## Specific Changes to D2.0 Draft Text

The specific changes proposed to the D2.0 802.11 draft text is presented below in revision mark format. Note that all changes are at the PHY level.

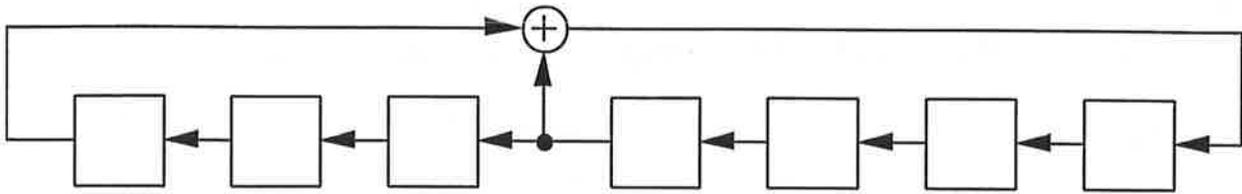
The hopping pattern is based on a pseudo-random sequence generated by a linear shift register with taps corresponding to the irreducible polynomial  $x^7 + x^4 + 1$  as shown in the figure below. All registers are initialized with ones.

The contents of the registers form 7-bit words with values from 1 to 127. The left-most register in the figure above is the most significant bit; the right-most register is the least significant. The irreducible polynomial produces a maximal length sequence which means that each value from 1 to 127 occurs once and only once in each cycle. Values less than 2 and greater than 80 are eliminated, leaving 79 values from 2 through 80 which corresponds to the frequencies 2402 through 2480.
